TITLE OF PROJECT: Wharton – Masonry Restoration to SW Exterior Stairs (FY24)

PROJECT NUMBER: CP23026

ADDENDUM NO: 01

OWNER:	Michigan State University 113 Student Services East Lansing, MI 48824
ARCHITECT:	Fishbeck 39500 MacKenzie Drive, Suite 100 Novi, MI 48377
DRAWING REVISION NO.:	A1
ISSUED HEREWITH:	
SPECIFICATION SECTIONS:	07 21 00
SHEETS:	DA-1, A-1, A-3, S-1, P-1, P-2
BIDS DUE:	January 24, 2024
This Addendum is issued to all Bid Set Holders, is a part of the Contract Documents, and modifies the previously issued Bidding Documents. Acknowledge receipt of this Addendum in the space provided on the Bid form; failure to do so may result in rejection of the Bid.

PARTIAL SECOND FLOOR PLAN
 SCALE: 1/8" = 1'-0"

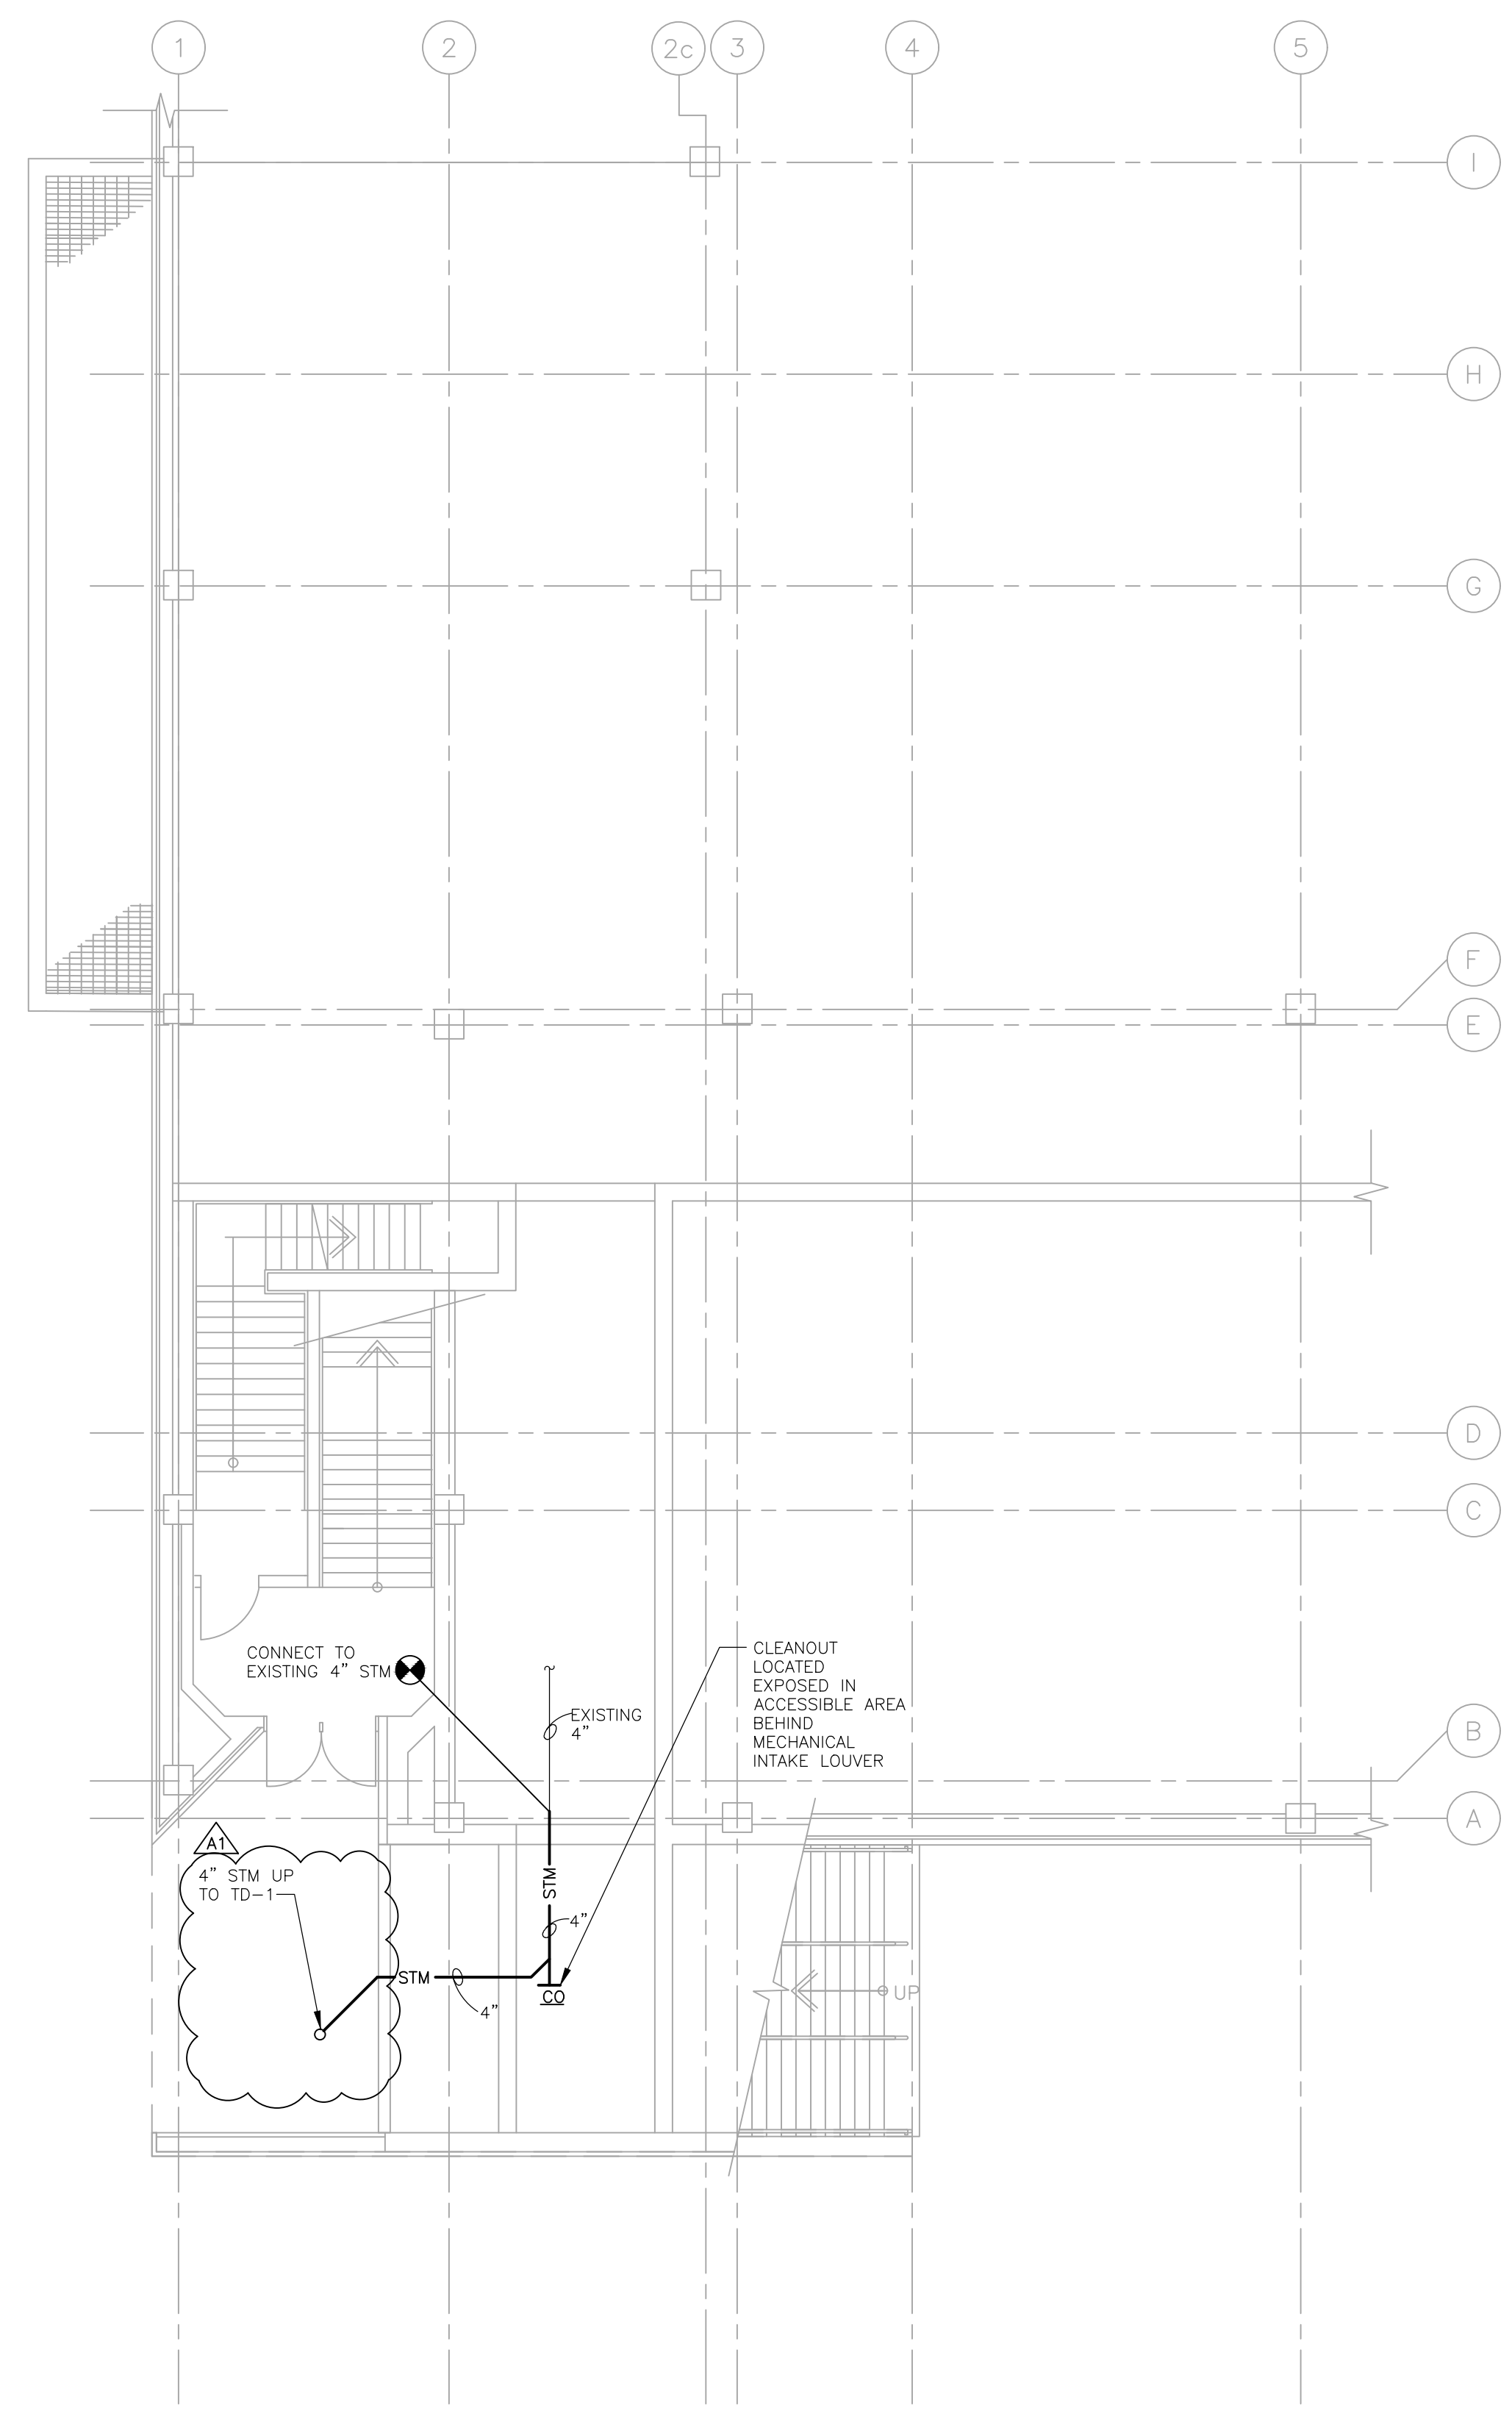
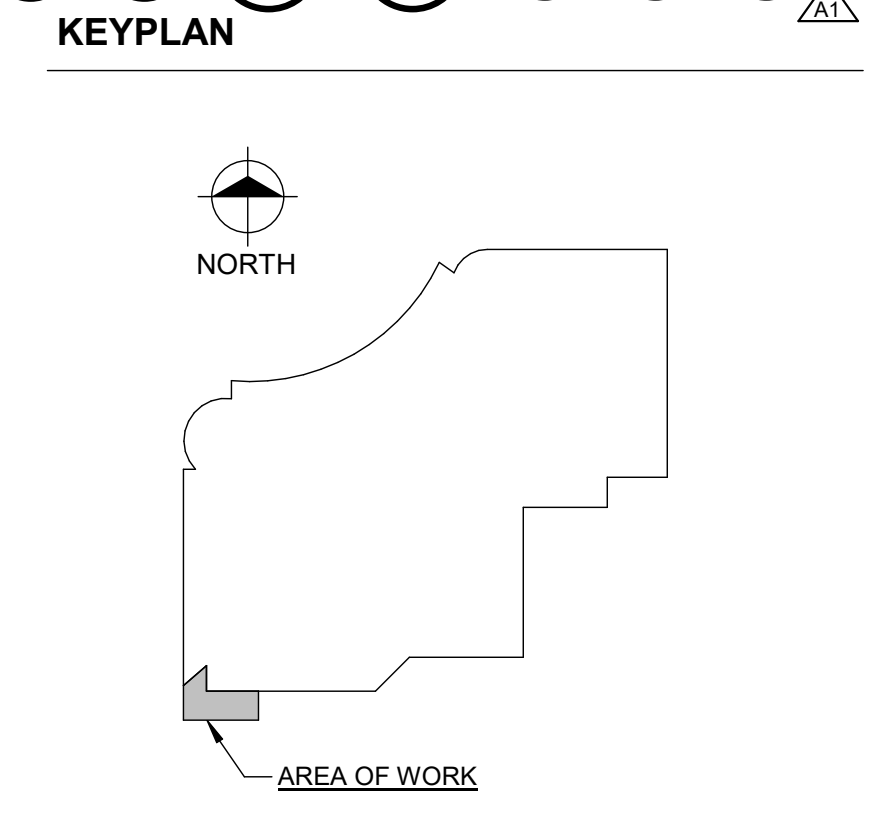
- A. Revised architectural, structural, and plumbing drawings to remove two (2) AD-1, area drains, replace with one (1) TD-1, trench drain, and revise associated sanitary pipe. Revise Fixture Schedule to remove AD-1 and add TD-1.
- B. Clarified in structural drawings that if landing elevations or field conditions differ from what is illustrated within the drawings to notify engineer and to not proceed with drain installation.
- C. Clarified in architectural drawings the location of under slab insulation to be replaced.

- KEY NOTES**
- INFILL EXISTING SLAB OPENING WITH CONCRETE.
 - CORE EXISTING SLAB FOR NEW FLOOR DRAIN PIPE. COORDINATE EXISTING REINFORCEMENT WITH PROPOSED CORES.
 - TOPPING SLAB. SEE ARCHITECTURAL FOR MORE INFORMATION.
 - NEW TRENCH DRAIN. INSTALL IN ACCORDANCE WITH MANUFACTURERS RECOMMENDATIONS. REFER TO ARCHITECTURAL FOR TOP OF TOPPING SLAB ELEVATION AT DRAIN. TOP OF FINISHED DRAIN SHOULD BE RECESSED 1/8" BELOW TOP OF TOPPING. SET THE DRAIN USING #4 BARS DRILLED AND EPOXY ANCHORED INTO SLAB WITH 3" EMBEDMENT. VERIFY TOP OF STRUCTURAL SLAB TO BE 871'-11 1/2" PRIOR TO DRAIN INSTALLATION. CHIP OUT A MAXIMUM OF 1/2" FROM STRUCTURAL SLAB. NOTIFY ENGINEER IF ELEVATION IS DIFFERENT OR IF FIELD CONDITIONS VARY AND DO NOT PROCEED WITH DRAIN INSTALLATION.

PARTIAL FIRST FLOOR PLUMBING PLAN
 SCALE: 1/8" = 1'-0"

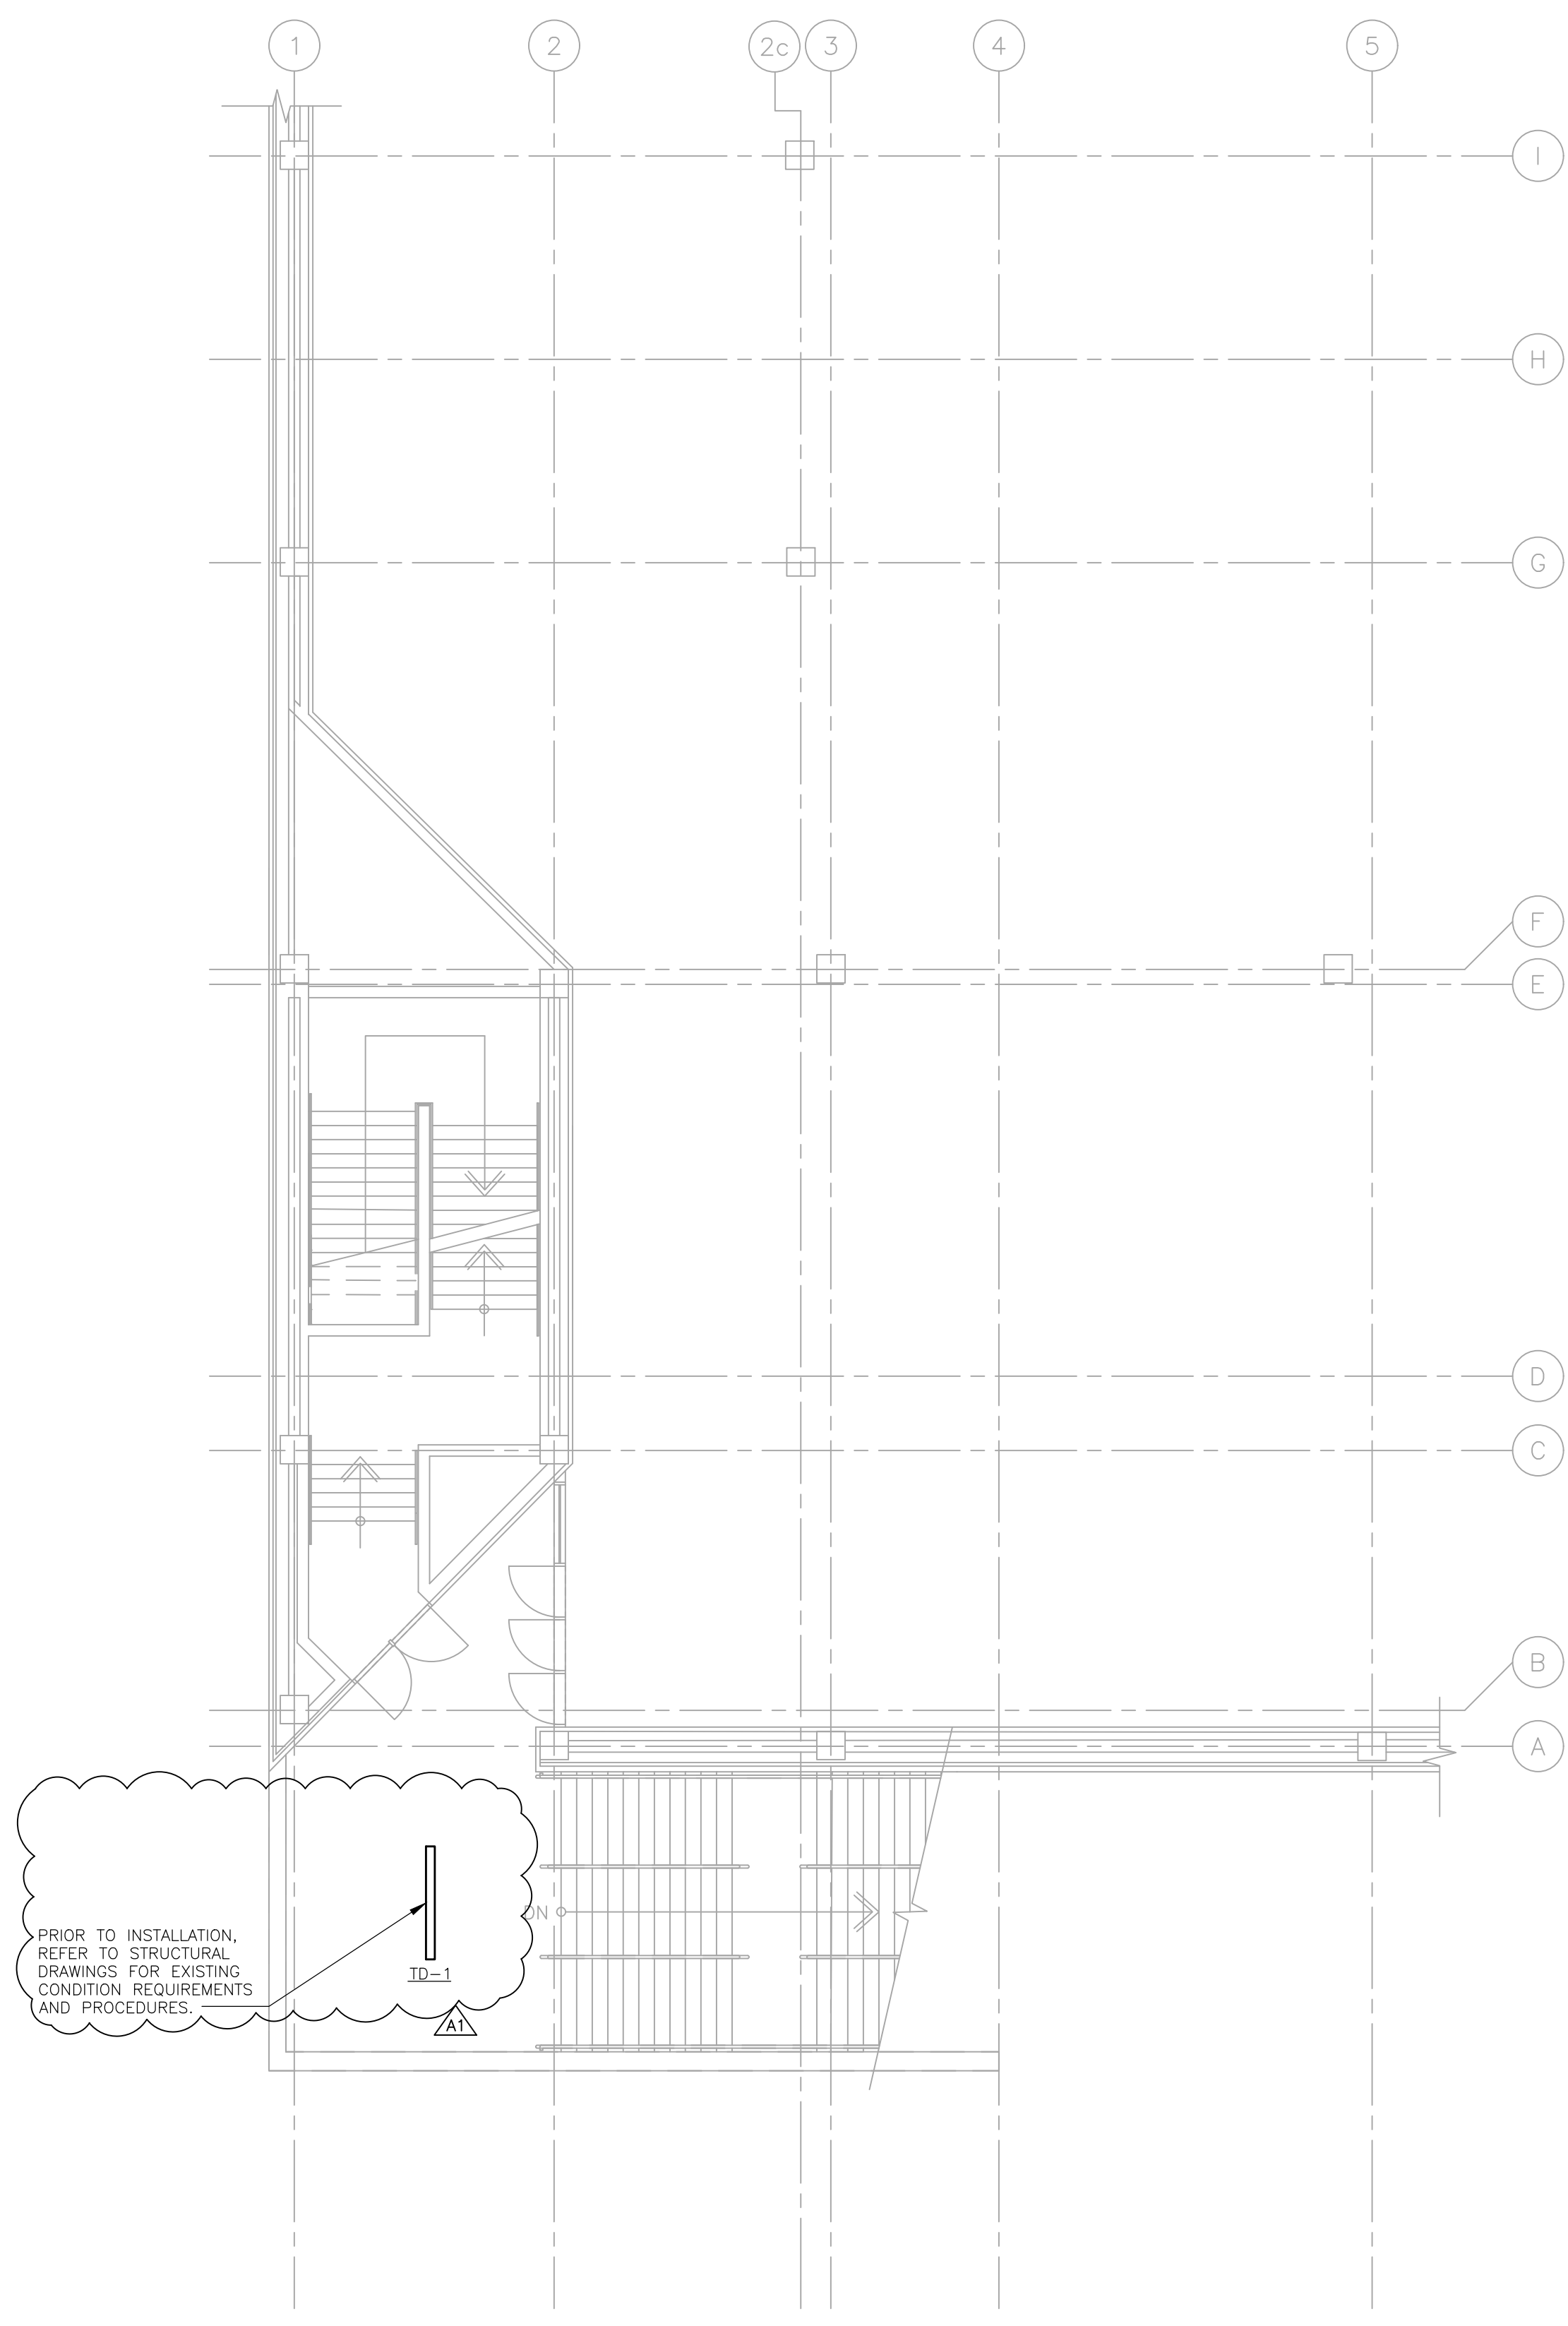
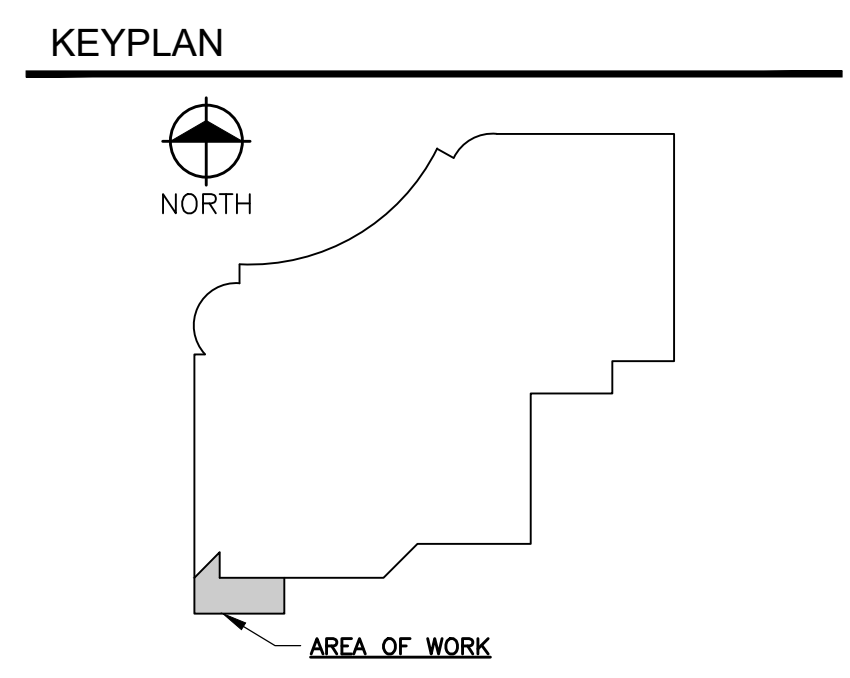
- C. **Question:** Clarify that the landing floor drains (2) should be changed to a single trench drain.
Response: Trench drain to be provided in lieu of two area drains. Refer to revised drawings within Addendum No. 1.
- D. **Question:** Clarify that there are no changes to the wiring of the new wall light and it still ties into the emergency panel.
Response: This is correct. Refer to Sheets E-1 and E-2 for lighting layout and requirements.

PLUMBING FIXTURE SCHEDULE	
IDENTIFICATION	DESCRIPTION
TD-1	TRENCH DRAIN: 1. ZURN MODEL Z886 HIGH DENSITY POLYETHYLENE (HDPE) DRAINAGE CHANNEL, 80"L X 6 1/4"W REVEAL, 4" NO-HUB BOTTOM OUTLET, VANDAL-PROOF LOCKDOWN, 1 1/2" RADIUS SELF-CLEANING BOTTOM WITH 0.75% BUILT-IN SLOPE. PROVIDE WITH MODEL SDD - STAINLESS STEEL DIAGONAL DECORATIVE GRATE - CLASS B, ADA COMPLIANT, HEEL-PROOF.
